RE: Bullitt Central High School (25-145)
Change Order 7—Site Soil Remediation

Change Order

PROJECT: *(Name and address)*
BCPS Phase III Athletics - Bid Package
No. 1 - Bullitt CENTRAL Physical Science
Center
1330 KY-44
Shepherdsville, KY 40165

CHANGE ORDER INFORMATION:
Change Order Number: 007
Date: 10-20-2025

Figure #2: Area of Observation; Undercut area

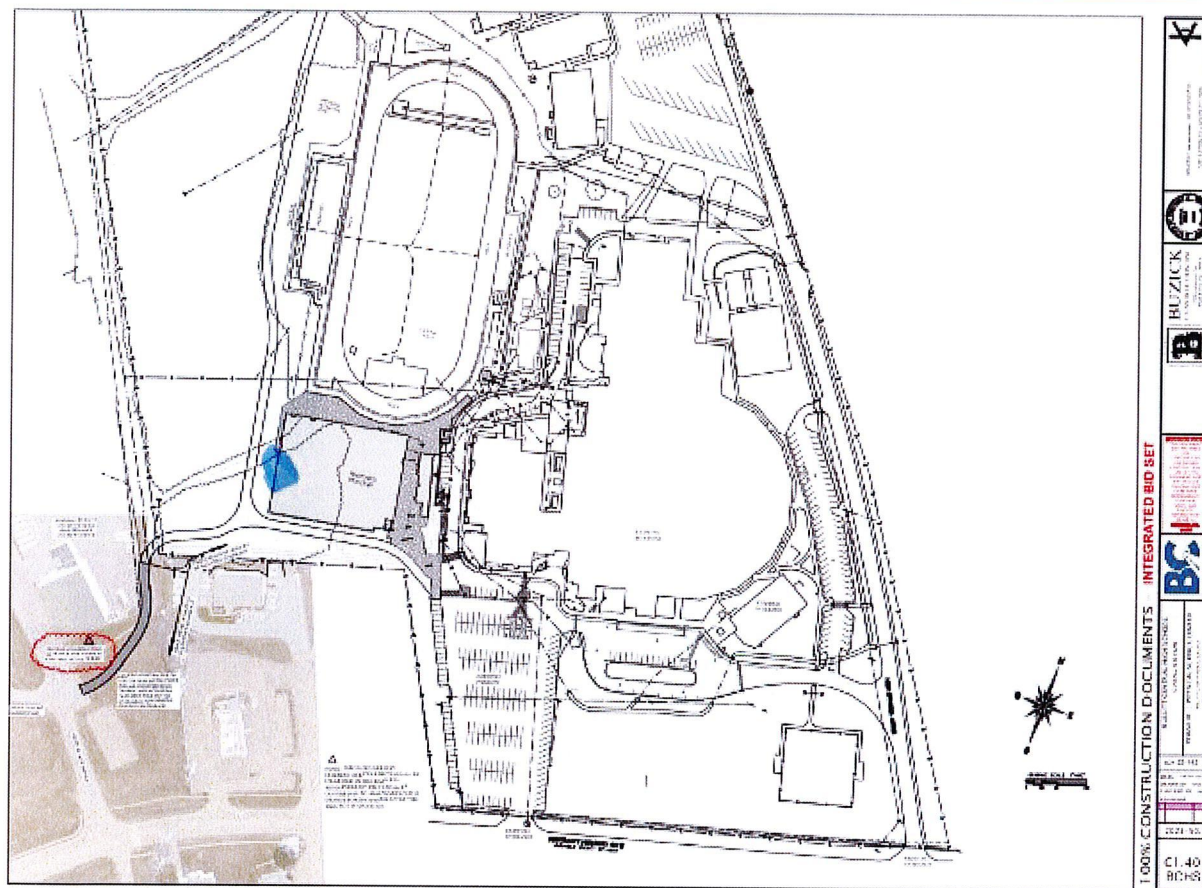
While on site, UES also observed a 3 ft undercut in the Building Pad. The area was highlighted in blue in figure 2 with measurements of 77ftx53ftx53ft. The area was triangle shaped and the three measurements were of the sides. Base on the calculations, total volume of material removed was approximately 155.8 cubic yards.

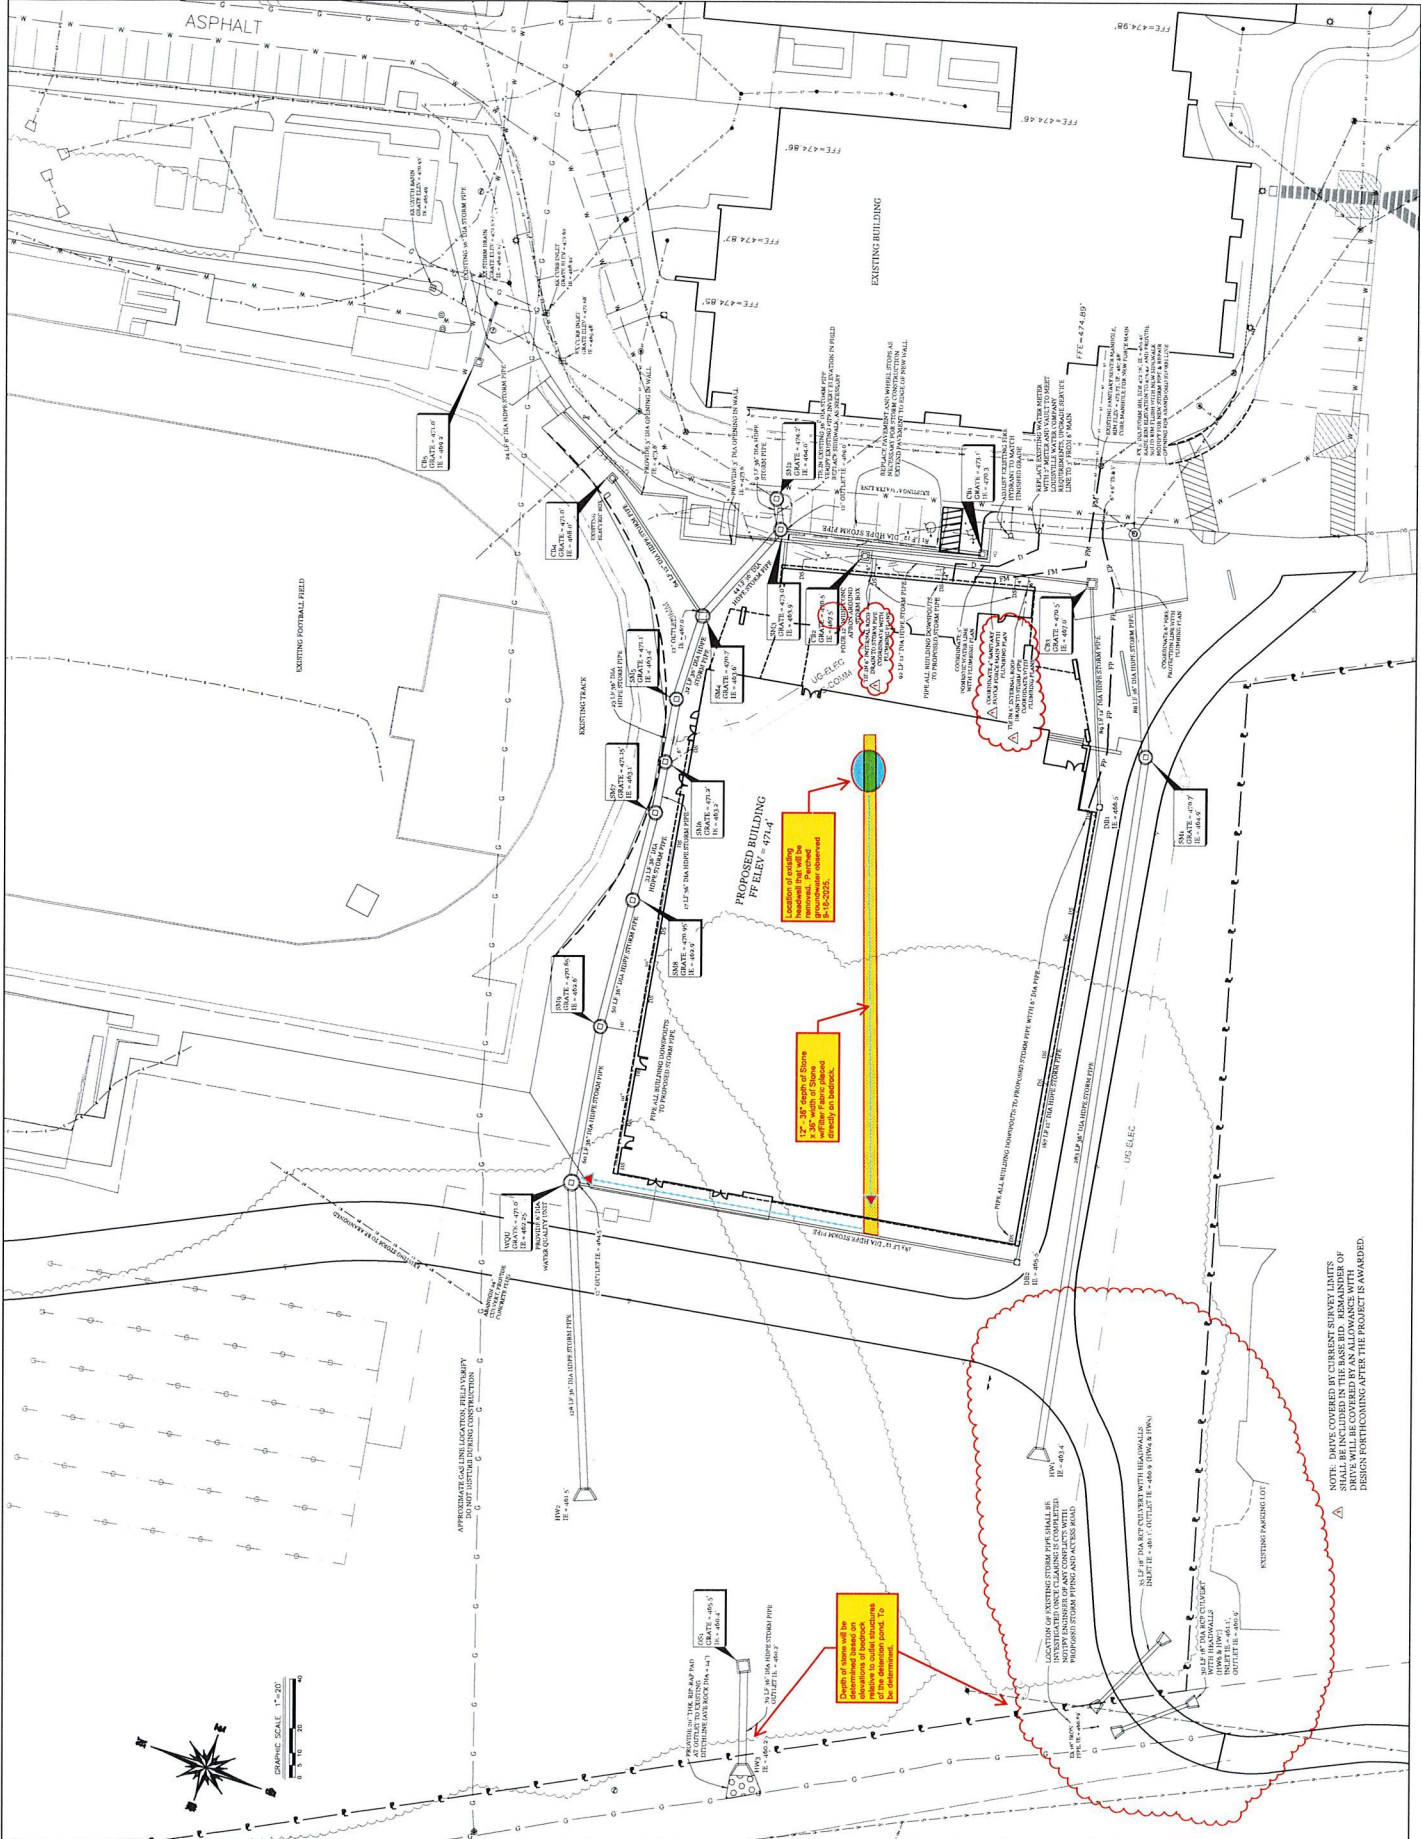
The top of the #57's will be placed to 461.70 to mitigate hydrostatic pressure on the soil within the building pad footprint. See attached markup for French drain exhibit

Buzick and JR discussed a proposed idea to mitigate the potential hydrostatic pressure below the building due to groundwater perched on top of bedrock. The proposal is the addition of a 12"-36" depth of #57s / Stone with filter fabric that is 36" width which routes the groundwater to the new, designed storm system. A schematic of this routing is attached and copied below my signature. After placement of this stone, the remaining soil fill would be placed to bring the building pad up to subgrade based on UES recommendations. The reasoning for this proposed idea is to provide a subsurface outlet that would allow ground water to flow down to a designed storm system via the voids of the stone, in essence French drain without the pipe. The blue arrows indicate the assumed path groundwater would flow to the design storm system.

We believe this approach to draining groundwater is acceptable. A few comments, we understand that the drain will lie on the existing bedrock surface. It should be buried deep in the fill and not be close (greater than 6 to 7 feet) to subgrade. As you suggested it is imperative that the drain is wrapped with filter fabric such that fines within the subgrade do not migrate into the drain. If you have any additional comments, or questions please let me know.
